Team Update 07

Game and Season Manual

Team Update 06

Team Update 04

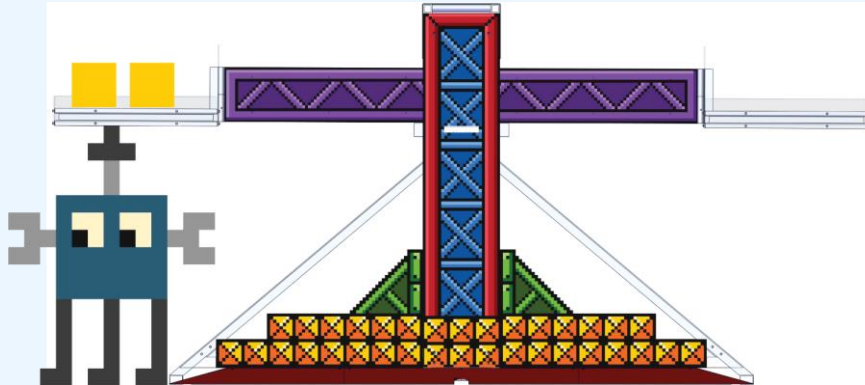
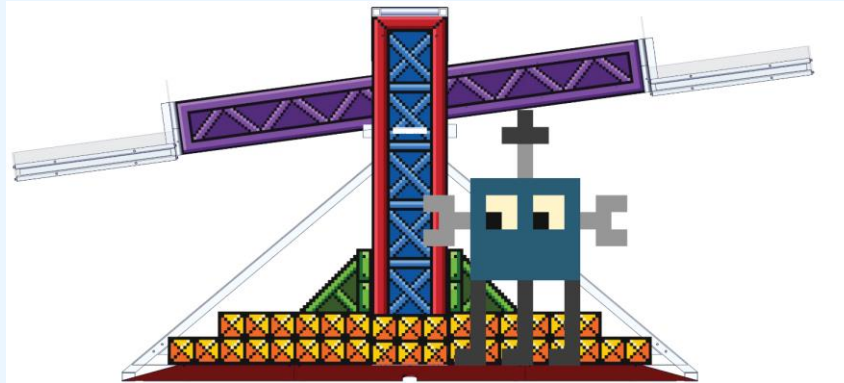
Example 1: A ROBOT may not hold the SCALE PLATE in a “balanced” state.

Example 2: A ROBOT may not hold a plate up.

Figure 3-14: SWITCH PLATE dimensions

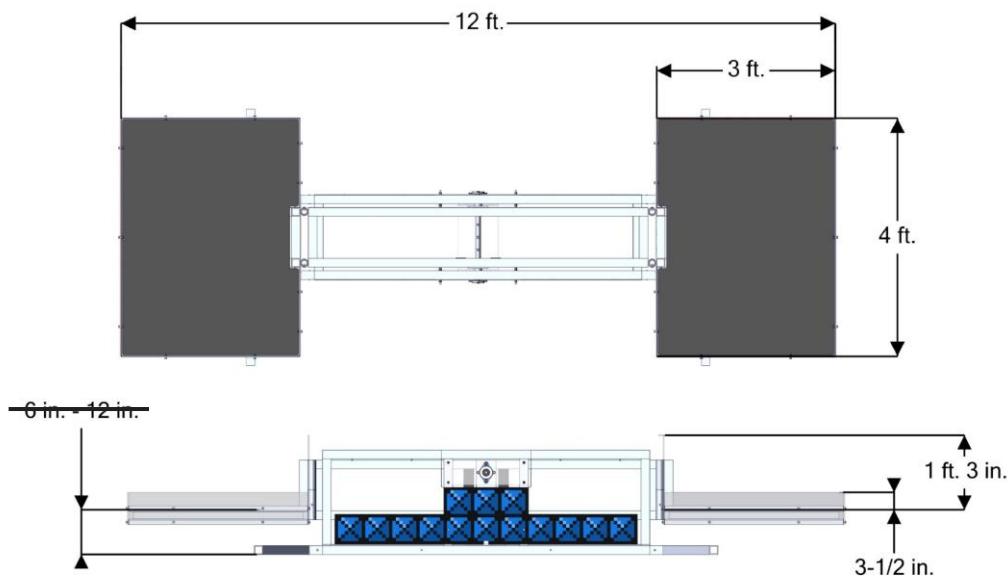
Figure 3-14 has been updated to remove the lower left dimension, which doesn't add value.

Figure 3-4: The SCALE (Note, cable protectors are shown, but are not part of the SCALE)

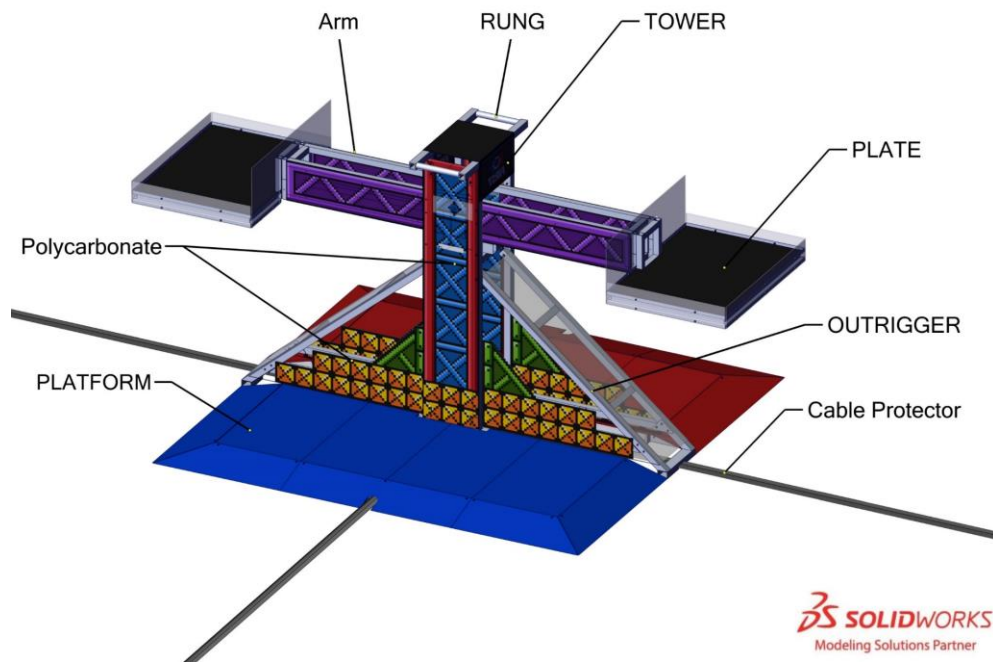
The BRICKS are graphics depicting golden squares surrounded by a black outline that extends 12 in. (~30cm) above the **horizontal** surface of the PLATFORM.

Figure 3-11: PLATFORM top length and width dimensions

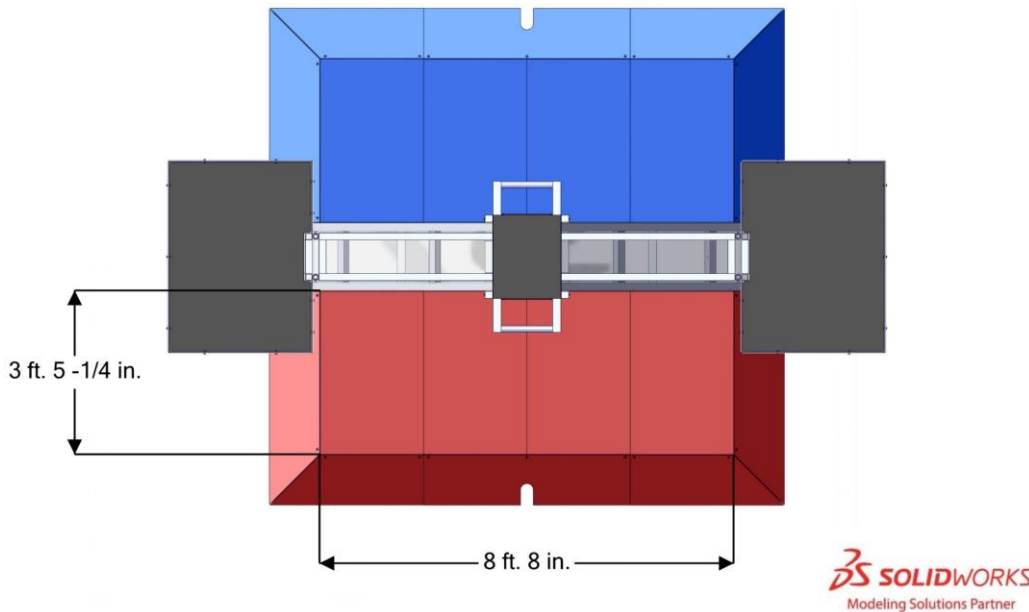
Located at the base of the SCALE, on each side, is a PLATFORM covered with ALLIANCE colored HDPE. The TOWER and OUTRIGGERS separate one PLATFORM from the other. Each PLATFORM top is 8 ft. 8 in. (~264 cm) wide by 3 ft. 5 ¼ in. (~105 cm) deep and 3 ½ in. (~9 cm) tall. The ramps leading to the PLATFORM includes ramps with a are 1 ft. 4 ¾ in. (~33 32 cm) run and long with a 15.35 deg. angle. The ALLIANCE colored tape that abuts the PLATFORM ramps is part of the PLATFORM.

Figure 4-1 Possible PLATE assignments

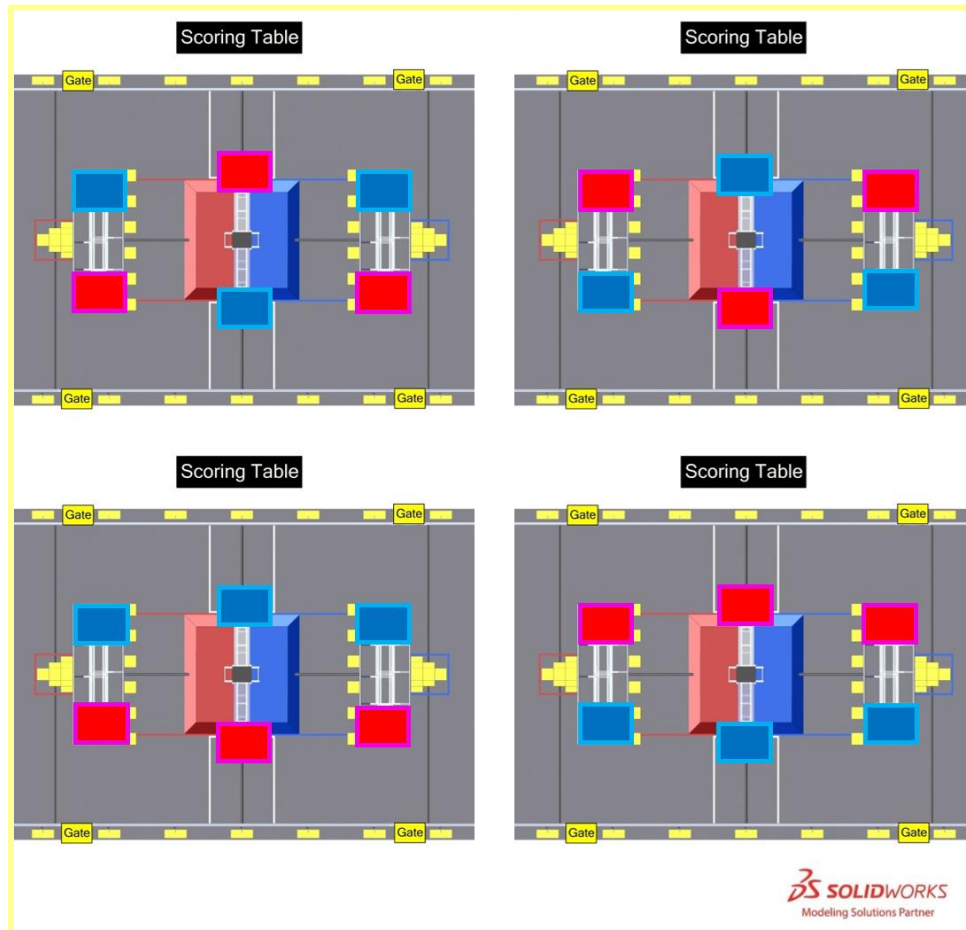
PLATES are randomized among the four states in Figure 4-1 and transmitted to the OPERATOR CONSOLE by the Field Management System (FMS). During AUTO, ROBOTS attempt to deliver preloaded POWER CUBES to PLATES, retrieve additional POWER CUBES from around the FIELD, and cross their AUTO LINE any time before the end of the stage.
